LiDAR Quality Assurance (QA) Report
San Francisco Bay LiDAR Project
NOAA Coastal Services Center
April 21, 2011

1 Executive Summary

The following LiDAR quality assurance report documents Dewberry's 3rd review of LiDAR data and derived products for the San Francisco Bay LiDAR Project. The data was flown by Fugro EarthData, Inc (FEDI) for the NOAA Coastal Services Center. The delivery of the data includes portions of seven California counties: Alameda, Contra Costa, Marin, Napa, San Francisco, Solano, and Sonoma.

Figure 3 - Point cloud from TerraScan with points colored by scan angle. The red points are where the scan angle is near or above 25° off from Nadir. The yellow and brown colors are scan angles under 20°.

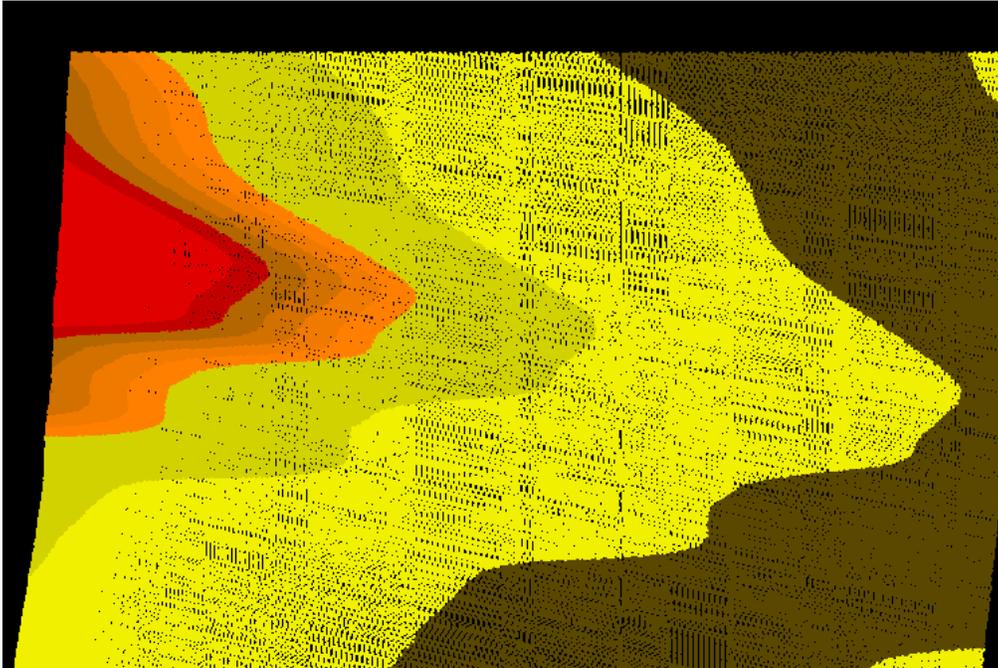
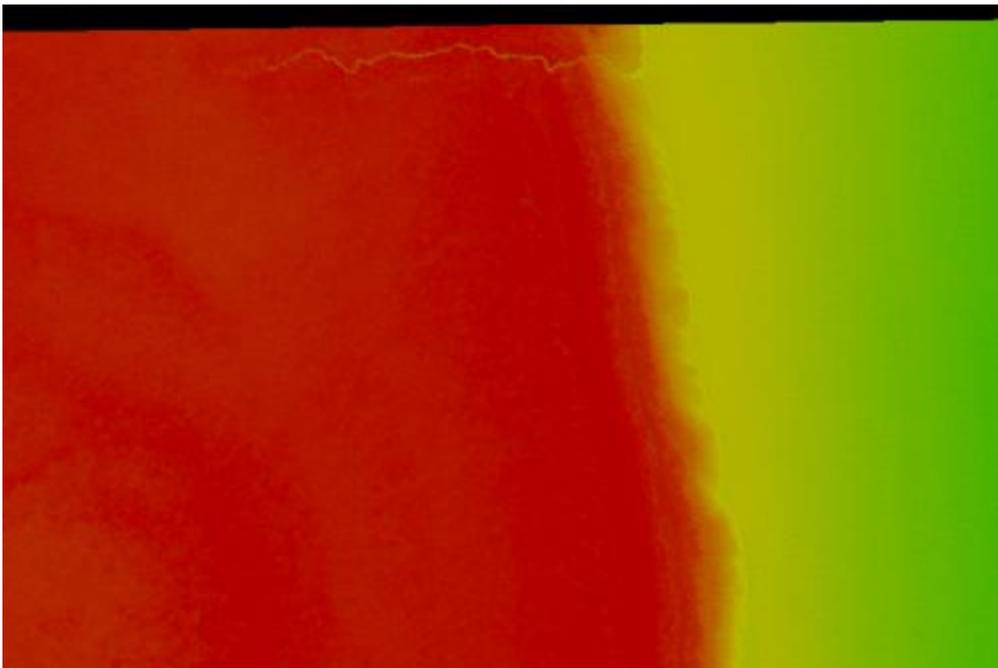
- 76 tiles have a scan angle from nadir greater than 20°. Tile C5445_42150 has the greatest scan angle at 29° and Dewberry loaded this tile to identify if this high scan angle adversely affected the quality of the LiDAR data. No visible flight line ridges or noise artifacts were visible in the data as a result of the high scan angle within this tile. Figure 3 to Figure 5 show the area in tile C5445_42150 that has the high scan angle and documents how this high scan angle does not have a noticeable effect on the ground model.

Figure 5 - Ground model from QT modeler colored by elevation showing the same general area as the figure above. No visible noise or flight line ridges are present as a result of the high scan angle.

Figure 7 - Ground density model of Tile C5385_42210. The area in red in the northern half of the tile is believed to flooded and in the 2nd delivery is outlined by a break line as a water body.

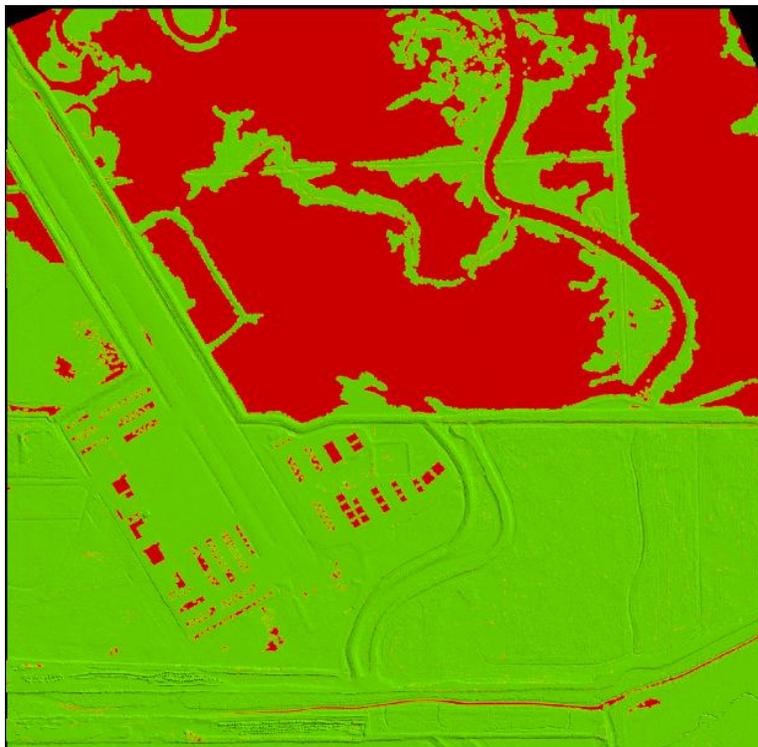
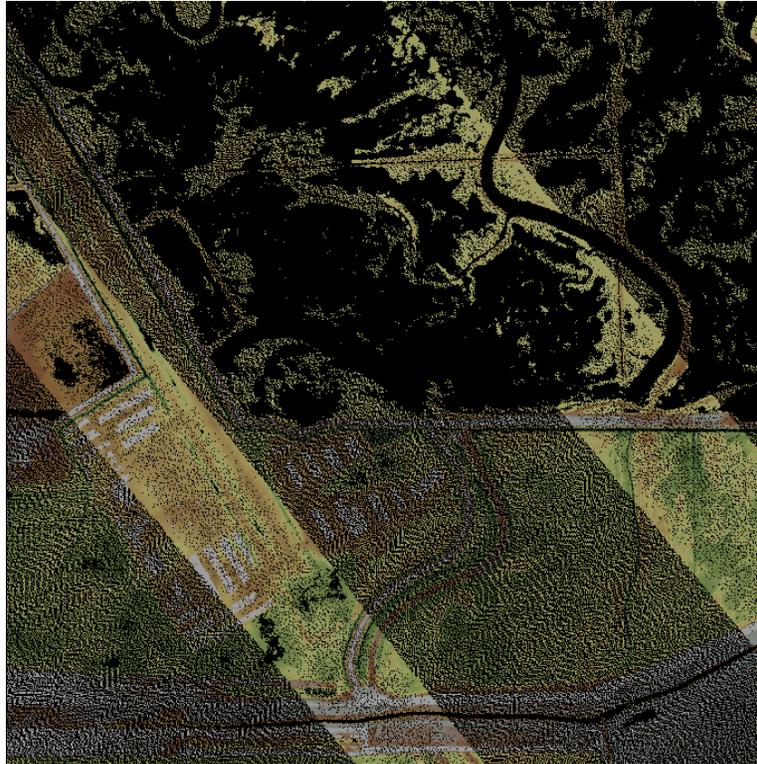
The issue of flooding still exists within 5 of the tiles (C5520_42285, C5370_42210, C5370_42195, C5385_42195, and C5385_42210). FEDI states that because the LiDAR was flown with the tidal window it does not require fixing. Dewberry provides examples below of this issue to make the end-client aware of the issue. FEDI also outlined several of the flooding areas as water bodies in the breaklines and therefore the images below are updated to reflect these changes.

Figure 8 - Full point cloud of tile C5385_42210 colored by elevation. Note the voids of data where the flooding exists.

Figure 10 - Ground density model of tile C5625_42195 that shows a linear feature created by two different flight lines. This image is from the 1st delivery and is fixed in the 2nd delivery shown below.

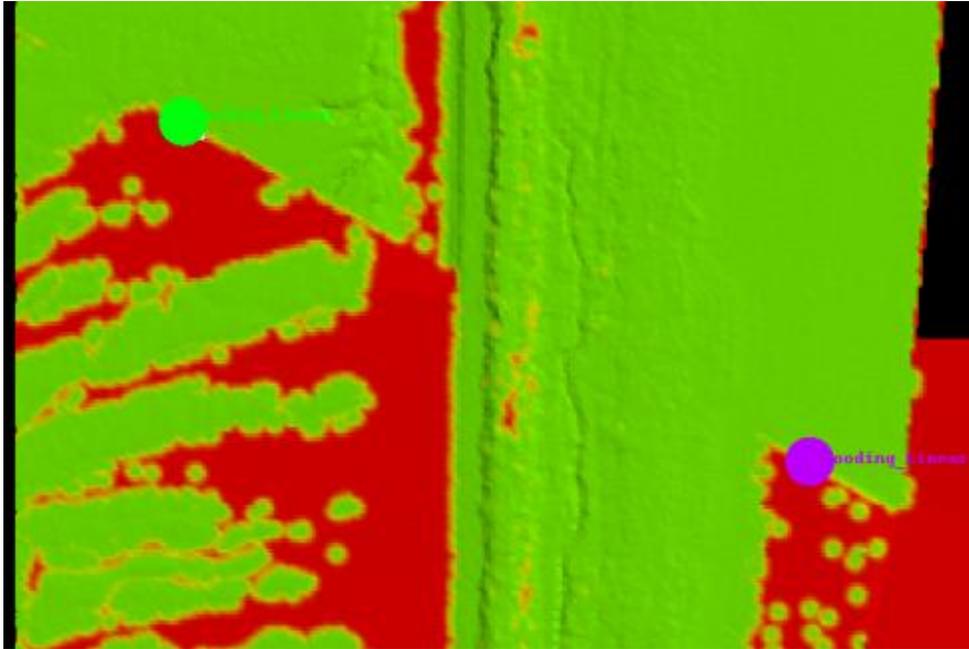
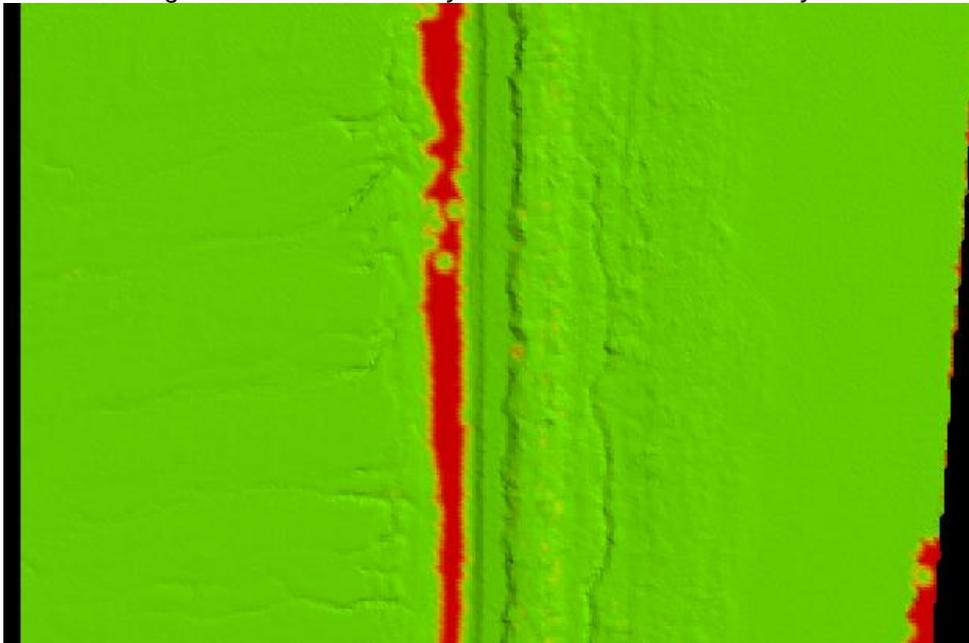
FEDI did fix some temporal, flooding issues. In the 1st delivery, a distinct line between an area of poor LiDAR returns due to water and existing ground points was identified. This issue is resolved in the 2nd delivery as shown:

Figure 11 - Ground density model of tile C5625_42195 that shows the linear feature no longer exists in the 2nd delivery.

Figure 13 - Full point cloud intensity image of tile C5505_41790 that shows a data void. The red line is the project boundary as provided by NOAA on March 4th, 2011.

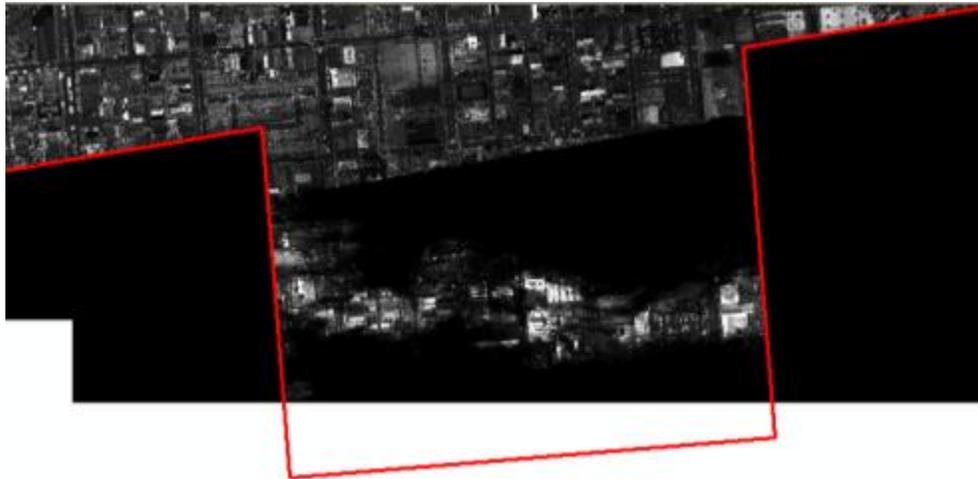
In the initial QC of the data, Dewberry identified four tiles that contain data voids. Three of these voids are fixed in the 2nd delivery (as shown below), but one tile still contains a void. The tile that still contains a data void is C5505_41790 and the void is clearly identified when viewing the full point cloud intensity

image (see Figure 13). This void still remained in the 2nd delivery. In the 3rd delivery, FEDI responded that they discussed this issue with NOAA and that “this area contains data from a cross-tie and [was not] QC’d as a production line. A data extents shapefile “SanFran_DataExtents_UTM10_NAD83_NSRS2007_m.shp” was provided with delivery identify the accurate coverage area. The intended project area has been covered and no loss of valuable data has occurred” (From San_Fran_Geodatabase Call_FEDI_REPLY_041411.doc, Dewberry assumes the delivery relates to a shapefile provided to NOAA). Based off this response, Dewberry no longer considers this to be an issue.

Figure 15 - Ground density model of tile C5460_42045 showing a linear feature where no ground points exist. This has been fixed in the second delivery.

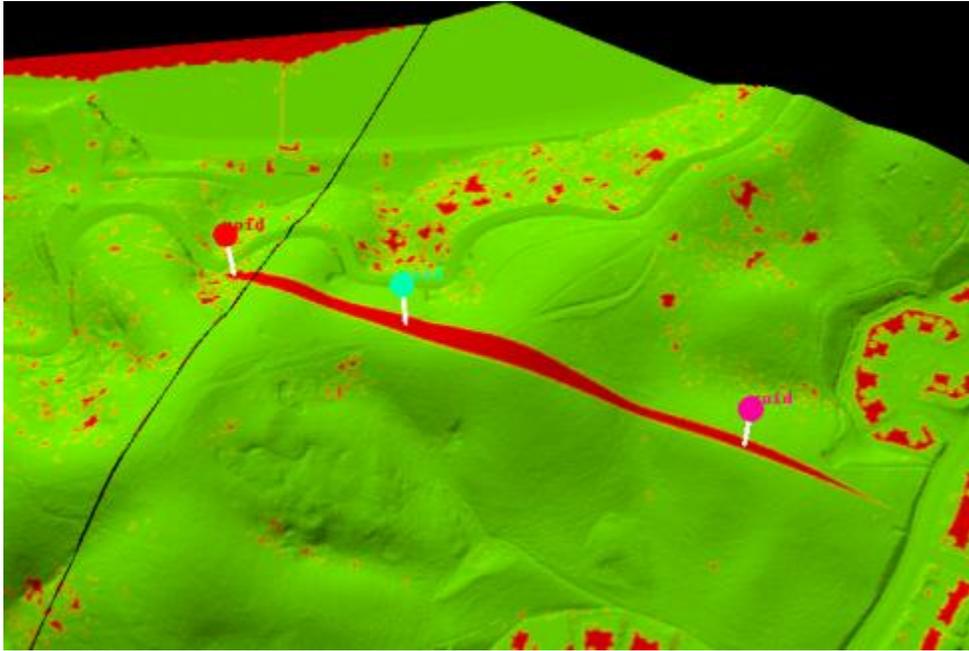
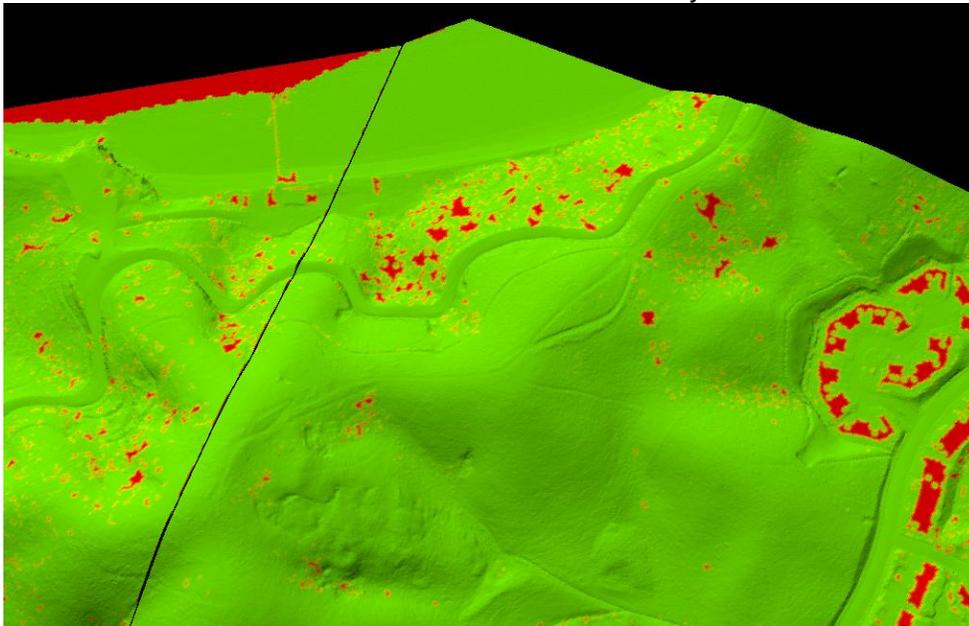
In the 1st delivery, Dewberry noted three other tiles (C5430_42045, C5445_42045, and C5460_42045) that contain a thin strip where no ground/unclassified points exist. In the 2nd delivery, FEDI has fixed these tiles. Figure 15 to Figure 18 show examples of the corrections.

Figure 16 – Ground density model of tile C5460_42045 showing that the linear void in the image above has been fixed in the 2nd delivery.

Figure 19 - Ground density model of tile c5535_42210 from the 1st delivery showing ground that was aggressively classified. This is fixed in the second delivery as shown below.

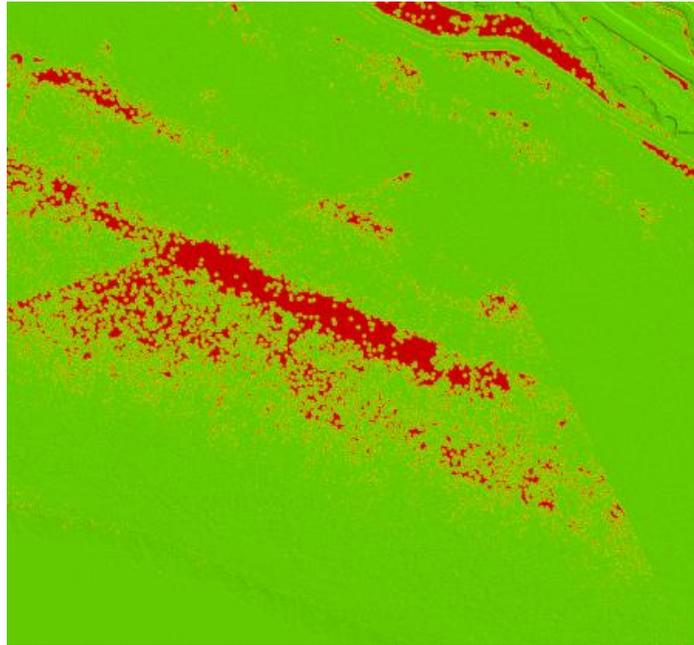
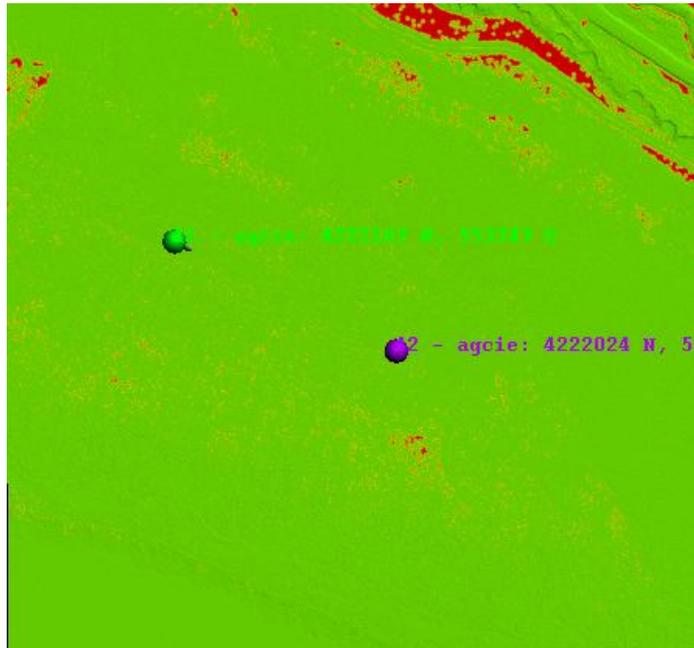
In the initial QC of the data, several areas were identified where ground points on the bank of a hydrographic feature or a road embankment had been aggressively classified. Aggressive classification happens when features that legitimately should be left in the ground are partially removed. FEDI addressed all calls in the 3rd delivery and no issues remain. Two examples of fixed aggressive classification calls are shown below in Figure 19 to Figure 22.

Figure 20 - - Ground density model of tile c5535_42210 showing that numerous legitimate ground points were put into the ground model.

Figure 23 - Ground density model of tile c5400_42135 showing a building artifact from the 1st delivery.

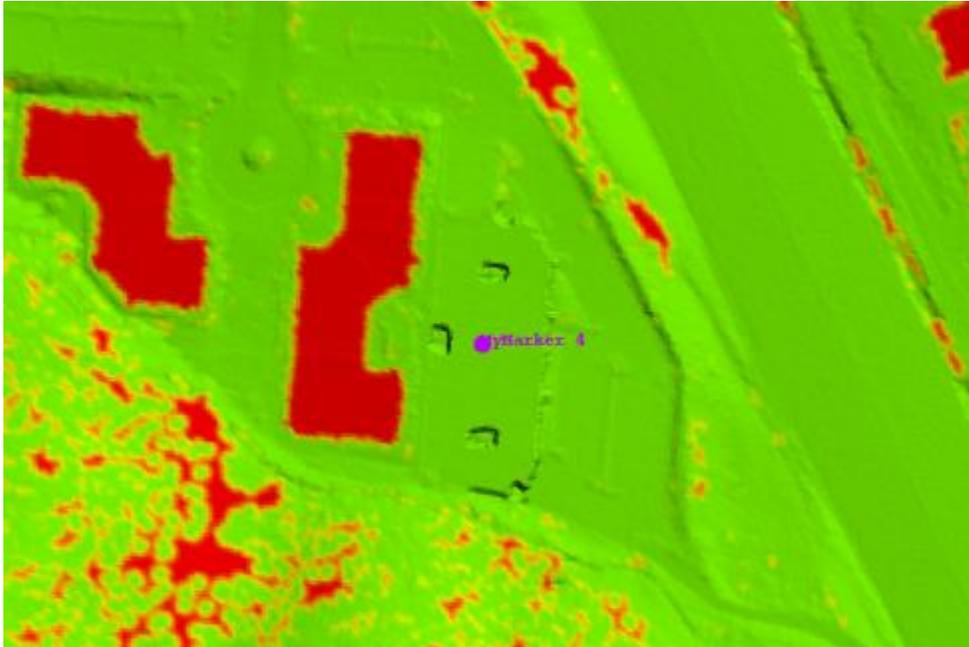
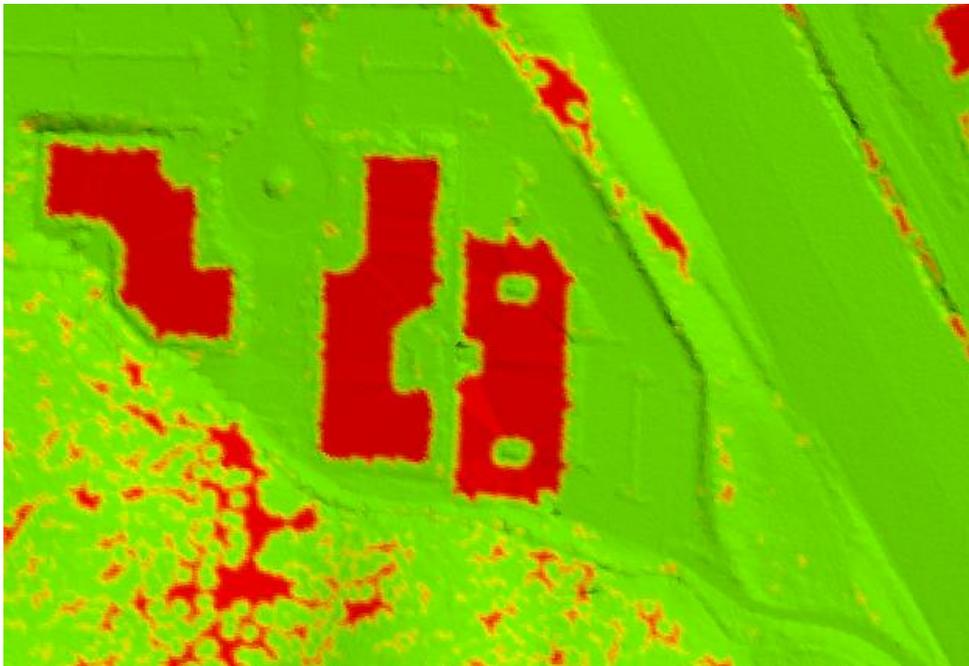
These classification issues are caused by ground points that are left in the dataset that should be removed. In general these are buildings, bridges, vegetation, or docks/piers. FEDI addressed and corrected all artifact calls identified by Dewberry in the 3rd delivery. An example of a correction is provided below in Figure 23 and Figure 24.

Figure 24 - Ground density model of tile c5400_42135 showing that the building is removed in the 2nd delivery.

Figure 25 - Ground Model of tile c5565_42000 from the 1st delivery showing a flight line ridge. This is fixed in the 2nd delivery as shown below.

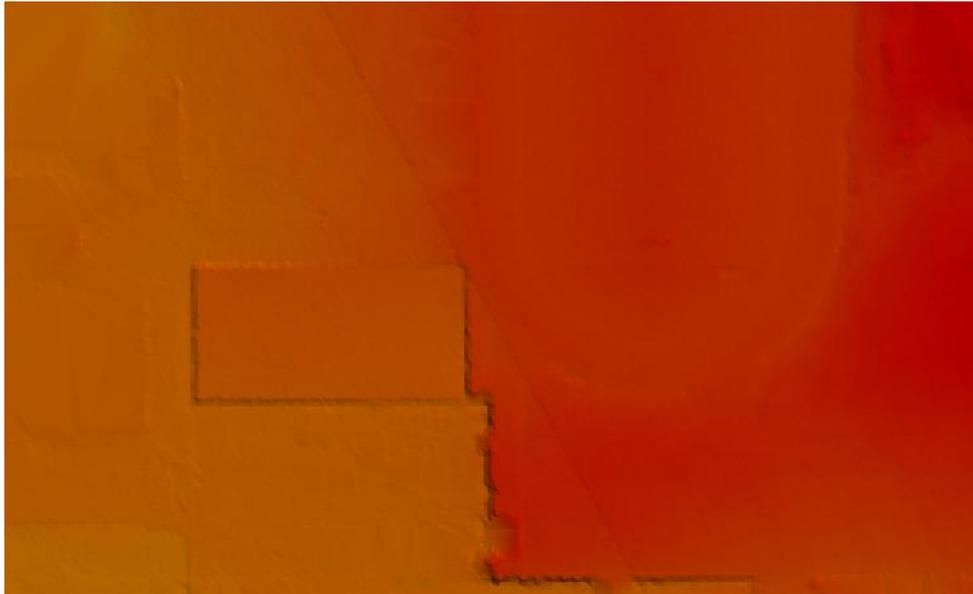
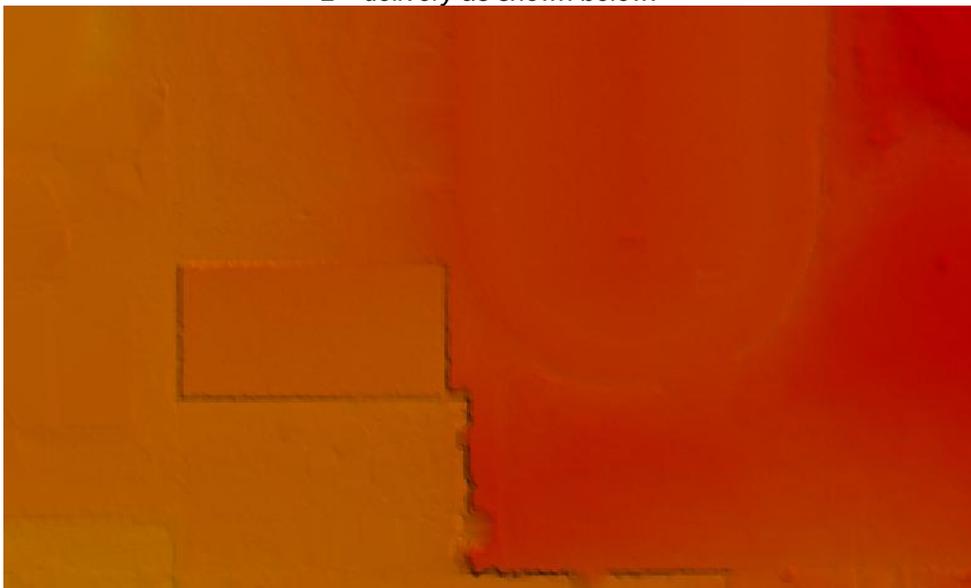
FEDI addressed all flight line ridges calls. Numerous flight line ridges were corrected by adjusting trajectory files. Two images are provided below to show the results of FEDI fixing a flight line ridge (Figure 25 and Figure 26). Several flight line ridges are temporal and therefore still remain in the dataset. Dewberry confirmed that no flight line offset occurs on buildings/roads and therefore the ridge is temporal. FEDI states that one flight line ridge is due to surface subtraction and a temporal difference of flight line acquisition. Dewberry agrees that according to the San_Fran_Geodatabase

Figure 26 - Ground Model of tile c5565_42000 from the 2nd delivery showing that the flight line issue is fixed.
